**GENOA CHARTER TOWNSHIP BOARD**

**May 2, 2016**

<b>Attention:</b>	Kelly Van Marter, AICP Assistant Township Manager and Planning Director
<b>Subject:</b>	Howell Medical Building – Site Plan Review #2
<b>Location:</b>	2765 E. Grand River Avenue – north side of Grand River, east of Meadowview Drive
<b>Zoning:</b>	GCD General Commercial District

**Re: Howell Medical Center  
Site Plan Review #2 Revised**

**Howell Medical Building**  
 SITE & UTILITY PLAN

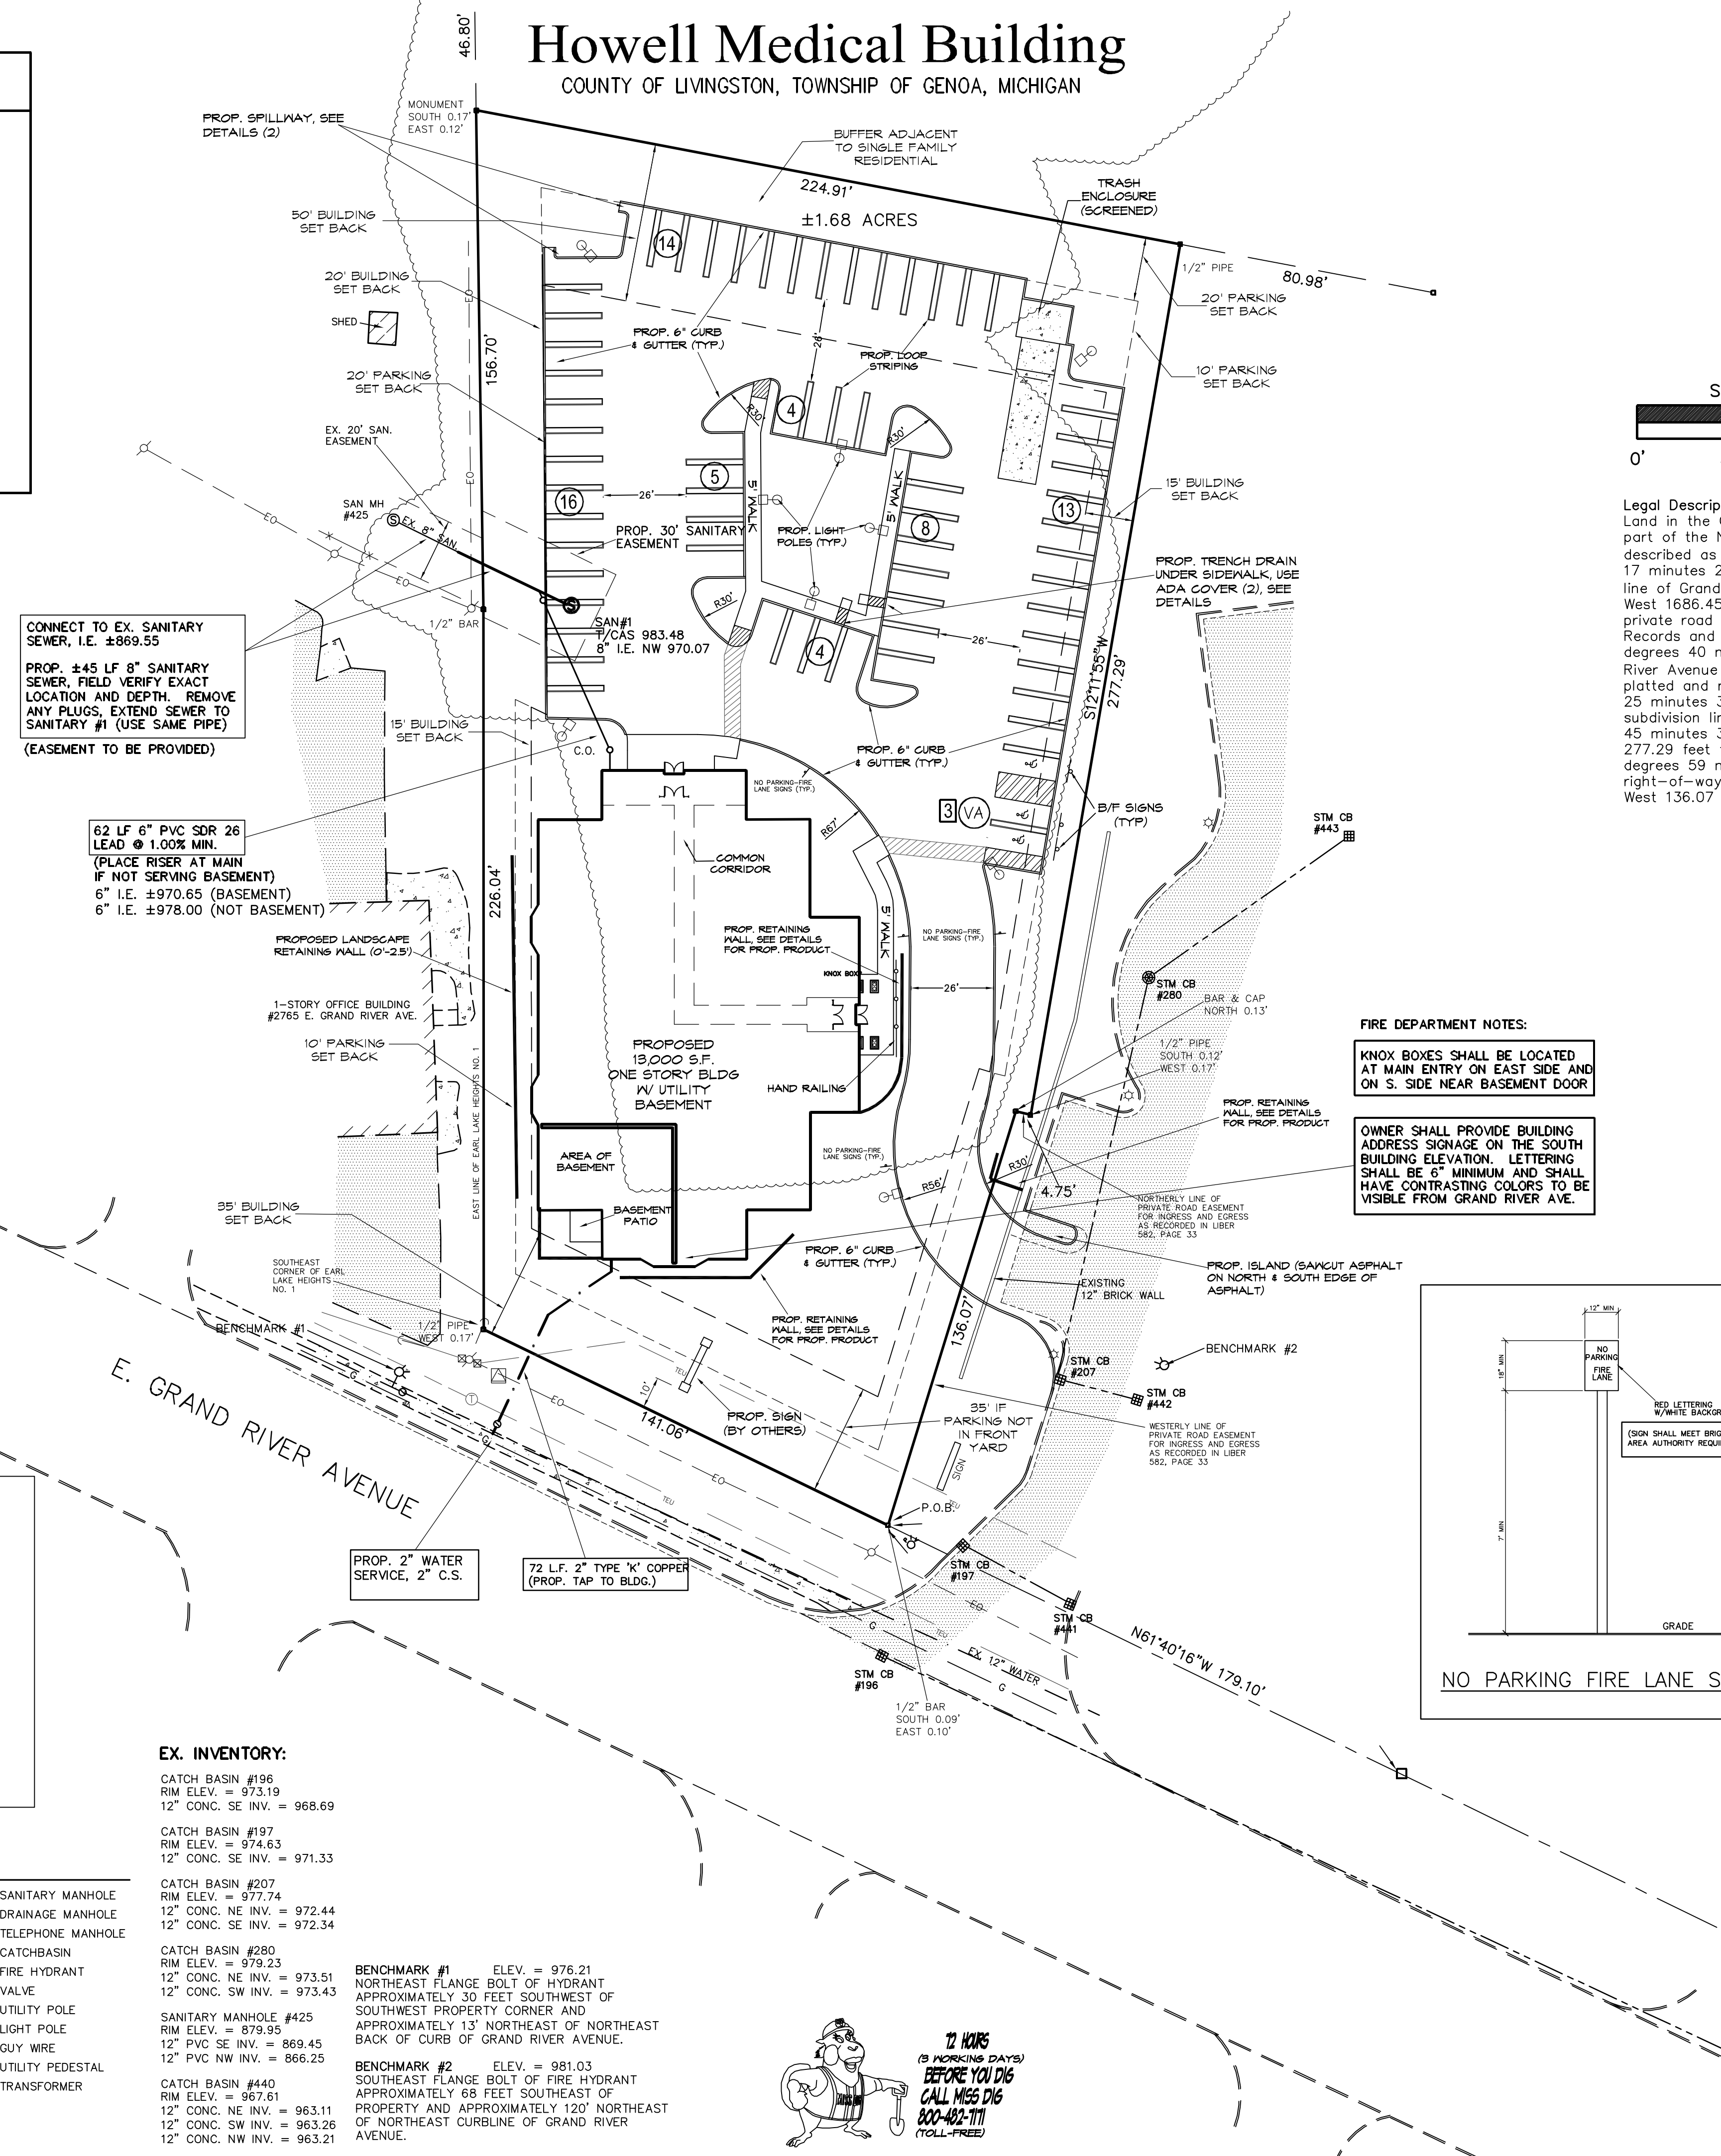
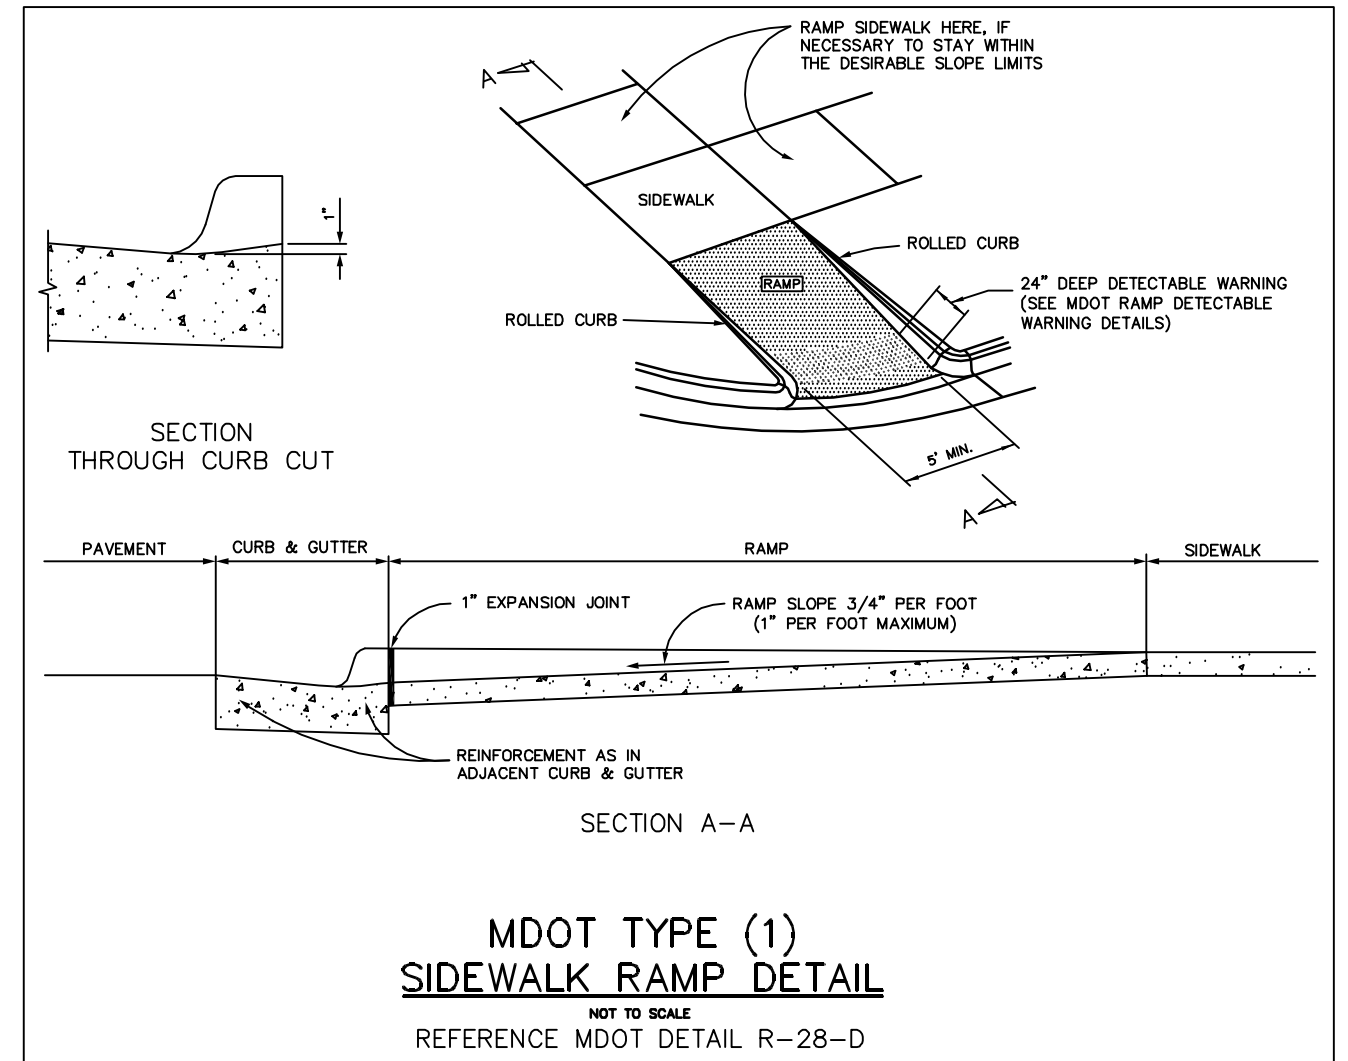
1. There is a discrepancy between the specifications listed on the cover and sheet 2 of 6 for the material called out for the sanitary service lateral. The standard material for sewer laterals is SDR 23.5 PVC. This should be corrected on the construction drawings that will be reviewed for the public sanitary sewer extension.
2. The storm outlet from the detention pond is currently shown as a 4-inch pipe. This should be revised to a 12-inch pipe with a 4-inch orifice plate to facilitate future cleaning of the outlet. The outlet also connects to the existing Grand River storm sewer which will require an MDOT permit. A copy of the permit should be submitted to the Township for your records.

1. It appears that the building will be provided with an automatic sprinkler system based upon the presence of a 6" fire protection water line. The FDC shall be installed on the street side (Grand River). **(Revised on Drawing, building and basement are exempt from Fire Suppression, MBC 903.2.11.1)**

**IFC 903**
2. The address to the building shall be a **minimum of 6"** high letters of contrasting colors and be clearly visible from the street (South Elevation). The location and size shall be verified prior to installation. **(Noted on Drawing)**

**IFC 505.1**
3. The access drive into the site shall be a minimum of 26' wide, and maintained at that width for circulation throughout the site. With a width of 26' wide the building side shall be marked as a fire lane. Include the location of the proposed fire lane signage and include a detail of the fire lane sign in the submittal. Access roads to site shall be provided and maintained during construction. Access roads shall be constructed to be capable of supporting the imposed load of fire apparatus weighing at least 75,000 pounds. Provide an emergency vehicle circulation diagram on plan. **(Revised on Drawing)**

**IFC D 103.6**  
**IFC D 103.1**  
**IFC D 102.1**  
**IFC D 103.3**
4. Access through the site shall provide emergency vehicles with a turning radius up to 50' outside and 30' inside while providing a minimum vertical clearance of 13 ½ feet. **(Noted on Drawing)**
5. The location of a key box (Knox Box) shall be indicated on future submittals. The Knox box will be located adjacent to the front door of the structure. There shall also be a Knox box placed at the basement door. **(Noted and Shown on Drawing)**

CONNECT TO EX. SANITARY SEWER, I.E. ±869.55  
 PROP. ±45 LF 8" SANITARY SEWER, FIELD VERIFY EXACT LOCATION AND DEPTH. REMOVE ANY PLUGS, EXTEND SEWER TO SANITARY #1 (USE SAME PIPE) (EASEMENT TO BE PROVIDED)

62 LF 6" PVC SDR 26 LEAD @ 1.00% MIN. (PLACE RISER AT MAIN IF NOT SERVING BASEMENT)  
 6" I.E. ±970.65 (BASEMENT)  
 6" I.E. ±978.00 (NOT BASEMENT)

**FIRE DEPARTMENT NOTES:**  
 KNOX BOXES SHALL BE LOCATED AT MAIN ENTRY ON EAST SIDE AND ON S. SIDE NEAR BASEMENT DOOR

OWNER SHALL PROVIDE BUILDING ADDRESS SIGNAGE ON THE SOUTH BUILDING ELEVATION. LETTERING SHALL BE 6" MINIMUM AND SHALL HAVE CONTRASTING COLORS TO BE VISIBLE FROM GRAND RIVER AVE.

**PHOTOMETRIC SITE PLAN**  
1"=30'-0"

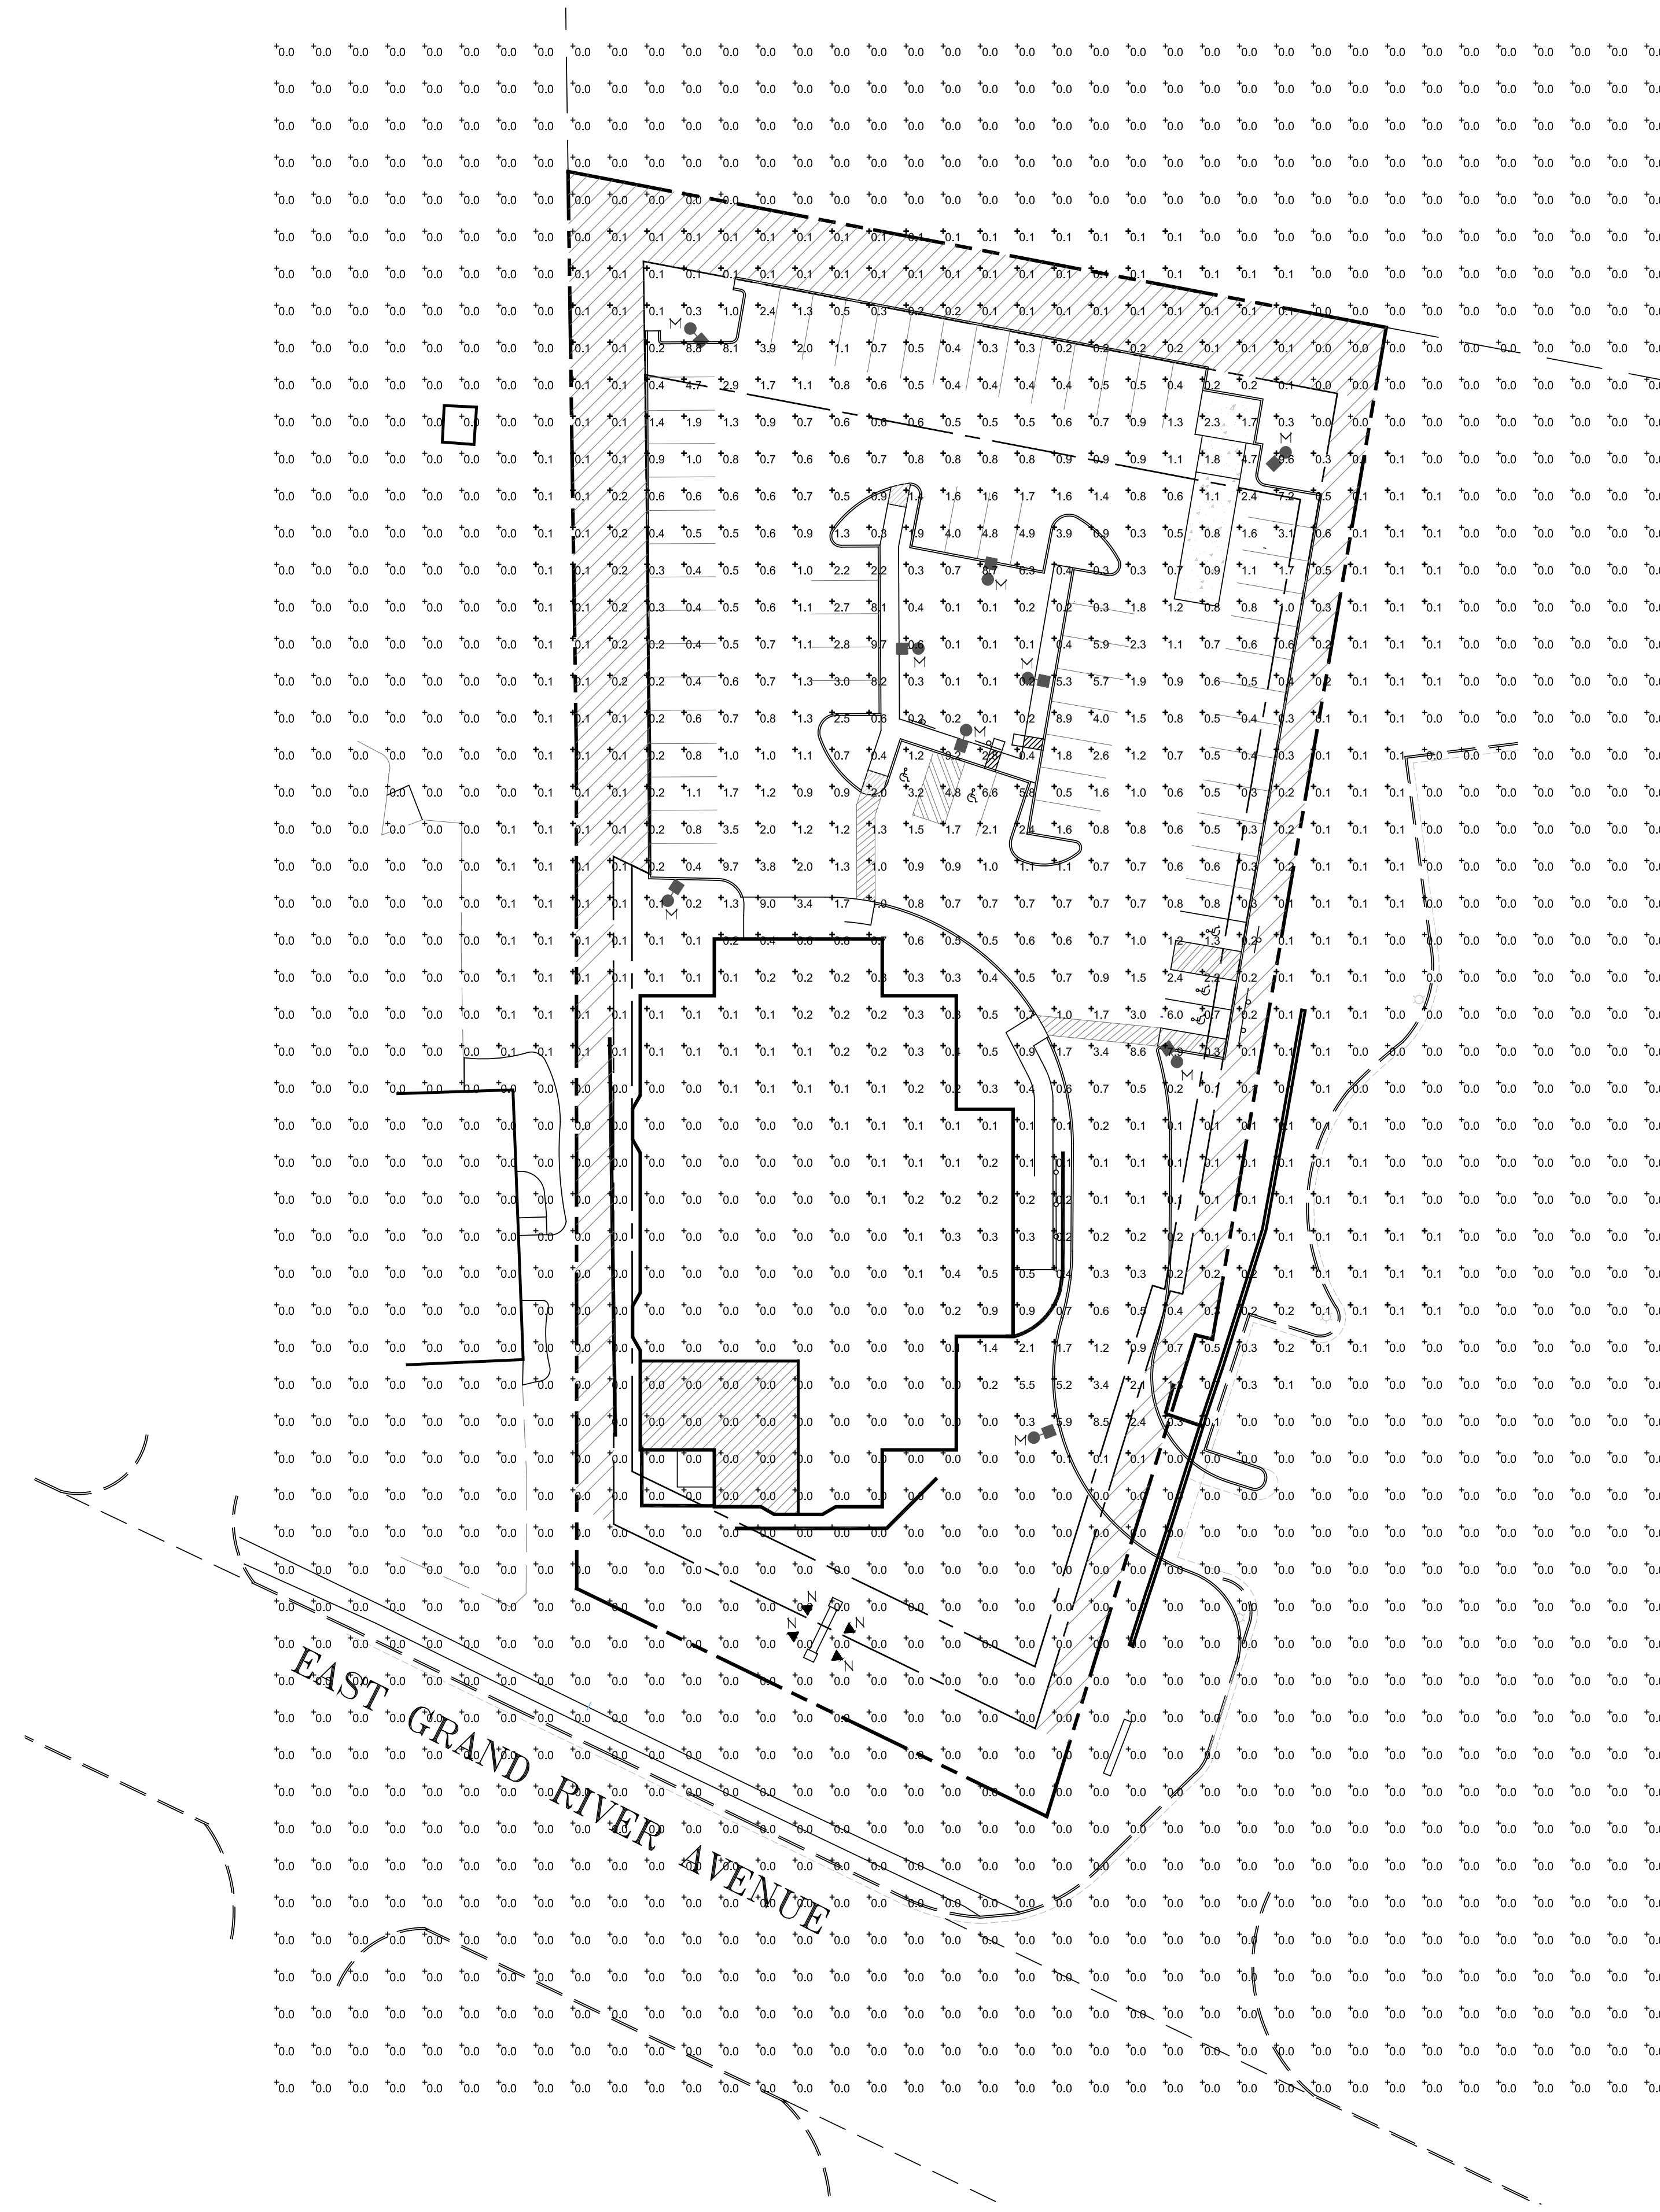
lighting hot spots on the photometric plan. Mr. Lenz explains that the revised plans provided lighting details. They are proposing a 15' max height LED lighting for the parking lot. Due to the nature of LED lights, there is an extreme cutoff making it very bright right under the light especially at the 15' height. To get the spread you need with light coverage you end up with the hot spots directly under the lights. They comply with the light levels at the property lines. To meet the ordinance they would have to increase the number of lights or use inefficient non-led lights. They hate to sacrifice energy efficient LED lighting and limited fixtures just to avoid the hot spots. Mr. Borden agrees that the LED fixtures are preferred however he is concerned with 40-42 footcandles on the lighting plan.

**8. Exterior Lighting.** The site plan proposes nine light poles for the parking lot and driveway. The photometric plan identifies several locations with light intensities well in excess of the 10-footcandle maximum. The applicant must revise the lighting plan to reduce light intensity. Light fixture details must also be provided.
